January 25, 2019

RE: New England Clean Energy Connect Project
Project Design Modification & Beattie Pond Photosimulations

January 25, 2019 Proposed Conditions: Panoramic view looking southeast to southwest from the northern end of Beattie Pond toward the proposed HVDC transmission line as revised January 25, 2019. Beattie Pond is a Management Class 6, Remote Pond.

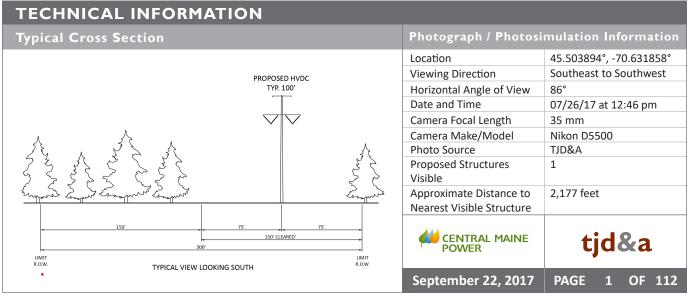
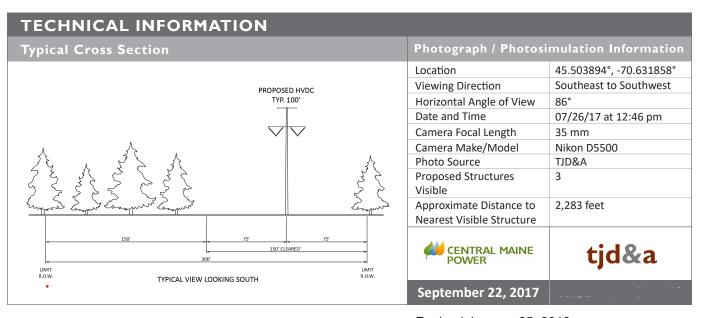
The original September 2017 caption incorrectly noted the distance between the closest structure and the viewpoint as 1,300 feet, but that distance is actually the approximate distance between the closest structure and the edge of the pond.

By re-engineering the transmission structures near Beattie Pond, the height of the closest structure (# 3006-794) has been reduced by approximately 39 feet below the structure height shown on the September 2017 original submission (see previous page). While a small portion of the top of the structure will still be visible above the treeline from a few areas on the pond, the structure will not appear above the skyline and will therefore be considerably less visually prominent, if it is noticeable at all. The top of Structure 3006-793 will be seen directly behind Structure 3006-794 from this viewpoint on the pond. Also, as a result of the re-engineering, a smaller portion of Structure 3006-795 will be visible above the treeline. In total, the tops of three HVDC structures and their shield wires will be visible just above the treeline, but will no longer be seen against the sky. The self-weathering steel used for the structures will minimize contrasts with the surrounding wooded hillside. Existing topography and shoreline vegetation will screen the rest of the Project from view. The re-engineered design will result in a reduced overall visual impact from the Pond and, as a result, the Project will be minimally noticeable from recreational users on the pond.
